**Subject:** Former United Nuclear Corporation Facility  
71 Shelton Avenue, New Haven, CT  
Final Status Survey Plan

General Electric (GE) is pleased to submit the revised Final Status Survey Plan (FSS Plan) for review and comment by the Nuclear Regulatory Commission (NRC). This FSS Plan has been revised to incorporate review comments by NRC and the Connecticut Department of Energy and Environmental Protection (CTDEEP) Radiation Division as communicated to GE by telephone on March 25, 2020 and later transmitted via email on April 21, 2020.

In addition to the revised FSS Plan, GE has developed a Comments Resolution document which provides responses to all comments identified in the April 20 email.

**Final Status Survey Plan, Revision 1 – Former United Nuclear Corporation, Naval Products Facility, New Haven, Connecticut**

Figure 4 - Survey Units with Sample Points

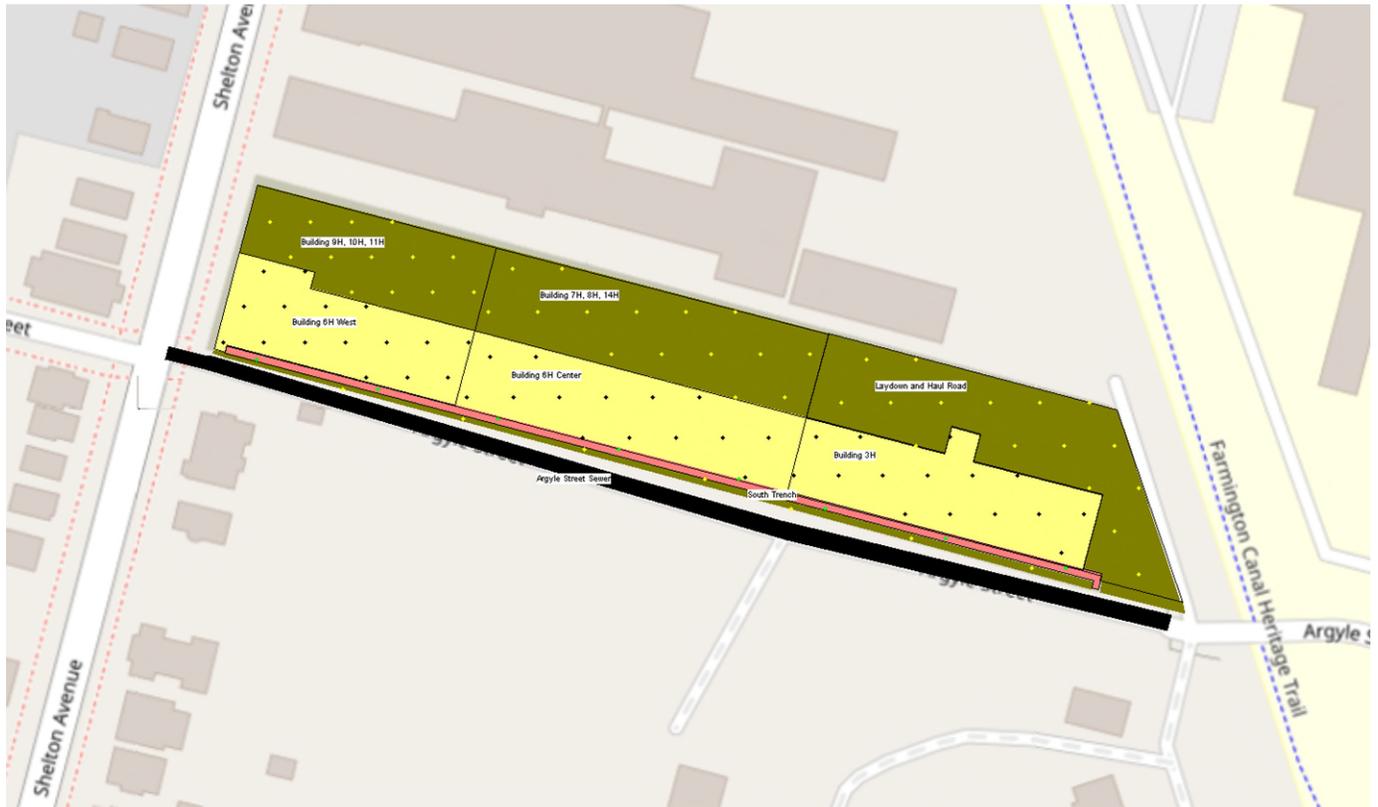
Comments	Resolution
<p>2. The South Utility Trench extends to the East of Building 6H, as indicated in Figure 4-1 of the RACR and provided below. However, the FSSP does not address this section of the trench. Please include this portion of the trench within the study boundaries.</p>	<p>As shown in Figure 4 of the revise FSS Plan - the South Trench was extended beyond the end of Building 3H to the property line. A portion of the figure is shown below.</p>  <p>South Trench</p>
<p>3. Section 4.3 indicates that a z-score will be determined for each data point collected during the gamma walkover survey. However, this section is titled Sample Collection. Section 4.1 states that the post-processed gamma survey data will be binned and graphically presented based on a multiple of background. Additionally, the investigation level presented in each section are different (gamma response greater than 4 times background in Section 4.1, and areas with a z-score greater than 3 in section 4.3). Please clarify the application of the z-score in Section 4.3, and address the discrepancy between investigation levels presented in Section 4.1 and 4.3. Also, clarify how the scan data assessment methods are intended to identify areas of elevated activity.</p>	<p>See section 3.3 "Investigation Criteria"- the discrepancy was removed. Gamma counts as multiples of background will be used to produce maps to illustrate spatial distribution of the gamma counts. Separately, the z score for each gamma count will also be calculated. Biased soil sampling will depend on the z scores. As noted in section 3.3 biased soil samples will be collected at those points with z scores greater than three (3).</p>
